UNITED STATES PATENT AND TRADEMARK OFFICE

APPLICATION NO.	FILING DATE	FIRST NAMED INVENTOR	ATTORNEY DOCKET NO.	CONFIRMATION NO.
10/078,601	02/19/2002	Xiaoming Ren	107044-0013	5541
24267	7590	02/18/2004	EXAMINER	
CESARI AND MCKENNA, LLP 88 BLACK FALCON AVENUE BOSTON, MA 02210			ALEJANDRO, RAYMOND	
			ART UNIT	PAPER NUMBER

Office Action Summary

DETAILED ACTION

FIG. 5

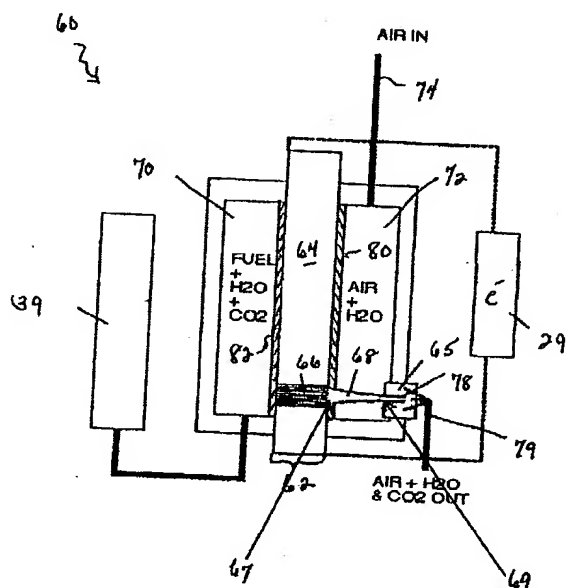
Figure 5 below depicts a passive control system using gas produced in the anode chamber for removing water from the reactive sites in the cathode chamber (SECTION 0085).

As apparent from Figure 5 and Corey et al's disclosure of SECTIONS 0014, 0017 and 0020), this fuel cell system: i) can be provided with a gaseous effluent port located in the anode chamber in close proximity to the anode side of the membrane electrolyte; and ii) does not have any liquid exit port in the anode chamber per se. Thus, it has a liquid closed volume anode chamber, and no anode liquid recirculation. These features act as a gaseous anodic product removal component. This structure also encompasses the absence of any water external pumping and/or active water removal element.

As previously mentioned, the fuel cell system of **Figure 5** above represents a passive fuel cell system (SECTION 0085). *Thus, it operates without external pumping of cathodically-generated water and without active water removal elements.*

As apparent from Figure 5 and Corey et al's disclosure of SECTIONS 0014, 0017 and 0020 and 0026, this fuel cell system: i) can be provided with a gaseous effluent port located in the anode chamber in close proximity to the anode side of the membrane electrolyte; and ii) does not have any liquid exit port in the anode chamber per se. Thus, it does have a liquid closed volume anode chamber, and no anode liquid recirculation.
